## LiDAR Quality Assessment Report

KS\_Area2-Lot5\_2012

KS\_25 COUNTIES LIDAR #1

# Project QA/QC Report Review

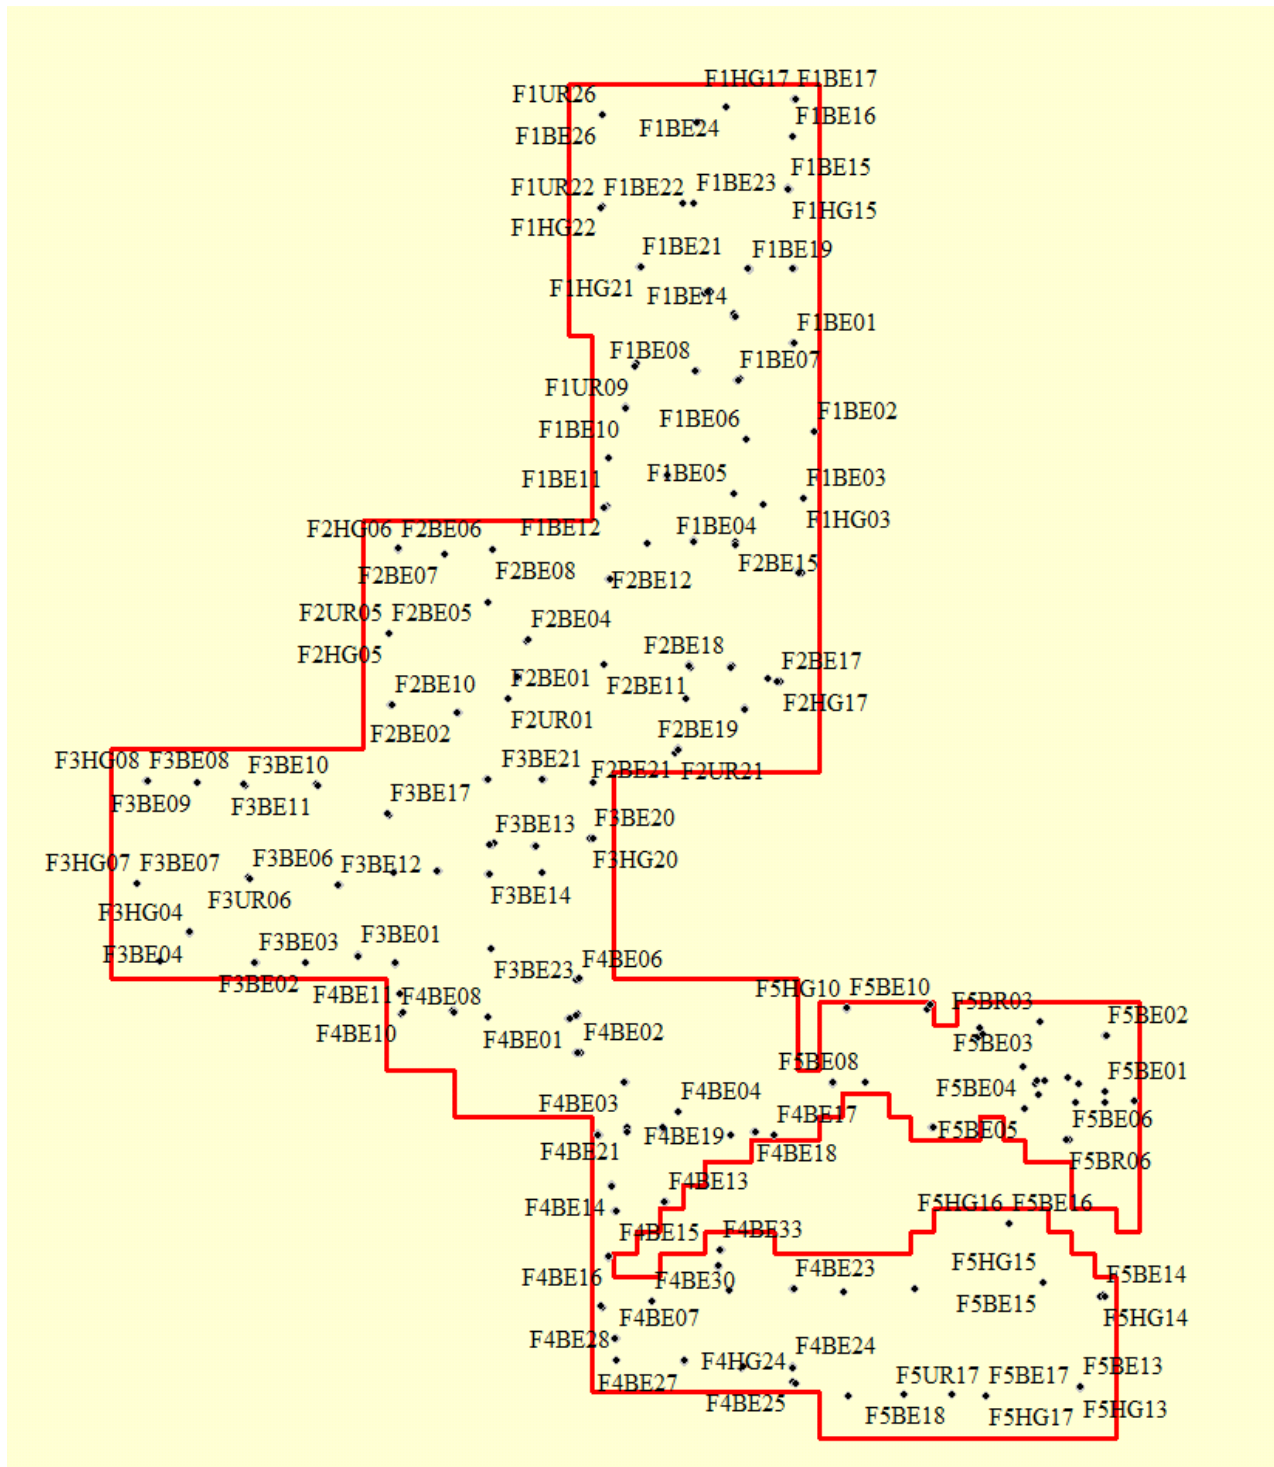
The LiDAR Final Report specifies standard specifications for LiDAR on page 5, Scan Angle, + or - 17 degrees on each side of Nadir. All swath extremely exceeds these scan angles.

Table 1: LiDAR Leica Acquisition Parameters, pg 8 LiDAR Final Report, also verifies scan angle as 17 degrees on each side of Nadir. Please explain Scan Angles found in Swath data.

The LiDAR Final Report specifies the Leica ALS-50 system was used to collect LiDAR for KS Area 2. KS Area 2 consists of 6 blocks. The maximum capability Field of View (FOV) at an altitude of 3000m is 75 degrees, + or - 37.5 degrees on each side of nadir for the Leica ALS-50. LP360 stats extractor indicates 8 swath files exceed -37.5 MIN Scan Angle (SAMN) and 11 swath files exceed MAX Scan Angle (SAMX) 37.5. Those files listed by block are:

All swath exceeds the scan angle specified in the LiDAR Final Report. Flightlines listed above exceed FOV capability of the Leica ALS-50 system. Please verify and explain.
